Hi-Fi Products
Service Bulletin

Model: SRS-D3K

No. 163

Subject: Hum During Silence

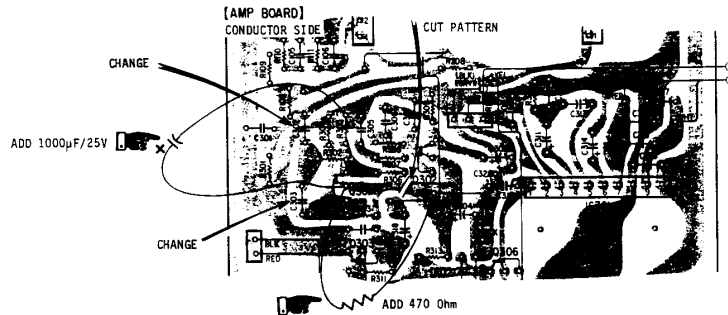
Symptom:
(54)

Hum may be heard during passages of silence when listener is positioned close to speaker, and ambient room noise level is very low.

Solution: If this symptom occurs, make the following changes to the "AMP" Board:

Ref. No.	Description		Part Number	
	Former	New	Former	New
C302	Capacitor, 0.12uF, Mylar	Capacitor, 0.1uF, Tantalum	1-130-496-00	1-131-402-00
C303	Capacitor, 0.1uF, Mylar	Capacitor, 0.1uF, Tantalum	1-130-495-00	1-131-402-00

Description	Part Number
Resistor, 470 Ohm, 1/6W, Carbon	1-249-413-11
Capacitor, 1000uF/25V, Electrolytic	1-124-557-11
